Parker Chelsea PTO Switch Bracket Update

Parker Chelsea Products Division would like to announce an updated version of our PTO switch bracket, **assembly PN 380668X**. This part will replace legacy bracket PN 379336. This new switch bracket features a more compact design, with a PTO engagement light integrated into the rocker switch.

Updated Bracket (PN 380668X)

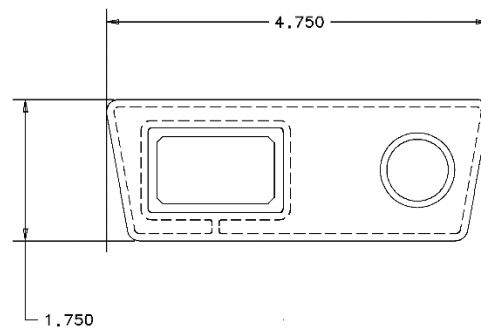
The new rocker switches (PN 75-P-45-12 for 12V circuits and 75-P-45-24 for 24V) utilizes an industry standard panel cutout of 0.830" x 1.450" allowing for integration into body builder consoles.

The transition to this new design began with 280, 870, and 890 Series switch installation kits. As inventory of legacy switch kits depletes, other series will follow in transition.
